State of New Mexico
Energy, Minerals and Natural Resources Department

Oil Conservation Division
UIC Program

Copy of Division e-mail correspondence to Apache concerning the use of dual-packer systems in waterflood operations at:

Submitted for the record by P. Goetze, Engineering Bureau, 05/10/2017

WBDU #137W

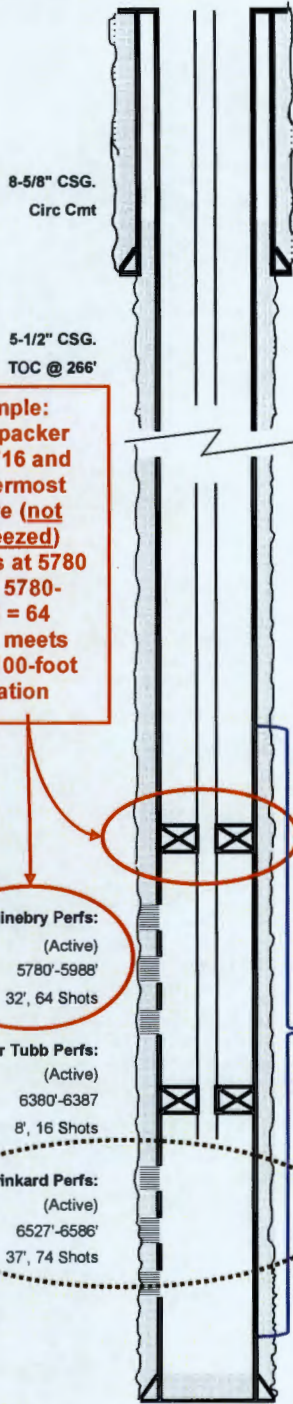
The only compliance issue becomes the "100-foot" setting distance. Using the language in R-12981 [Ordering Paragraph (12) with "a seal bore assembly set within 100 feet of the uppermost injection perforation" versus WFX-857 wording of "packer located within the 100 feet of the injection intervals"] and after discussion with District personnel who are responsible for UIC inspections, the upper or first packer would be the packer setting to assess compliance with the order. The distance between this packer's setting depth and the uppermost active perforations would be the test for setting within 100 feet (see attachment for example of WBDU #137). The uppermost active perforations will be the Blinebry perfs which are still "active", in this usage – have not been sealed off by casing or squeezed with cement, even though the EOR activities are focused on the deeper Drinkard perforations. So for the example provided with WBDU #137, no exception would be for the 100-foot distance.

Example:
Top packer
at 5716 and
uppermost
active (not
squeezed)
perfs at 5780
feet: 5780-
5716 = 64
feet; meets
the 100-foot
limitation

Summary: Division would approve the use of dual packer assembly (without additional remedial cementing or casing) in all three EOR projects as long as the existing well construction can be used with compromise to the well's integrity and the use is within the limits of the respective Unitized Interval. Where there is an issue with the packer setting and distance to the uppermost perforations, these will be handled on a case-by-case basis with the opportunity for the issuance of Packer Setting Depth Exception letters by Division to resolve these items. Additionally, the Division is recommending the following guidance with dual-packer assembly use:

1. The dual-packer assembly must be set within the defined interval (Unitized Interval) for each respective EOR project. If the upper packer is not within the upper limit of the Unitized Interval, then an exception through an order or letter request must be submitted to the Director (hopefully following discussion between Apache and the Division to review the situation).
2. The MIT requirements [for testing prior to returning to operation] are still in effect if either packer is re-seated or relocated.
3. Apache shall provide a final construction diagram with the installation of any dual-packer assembly approved by District.
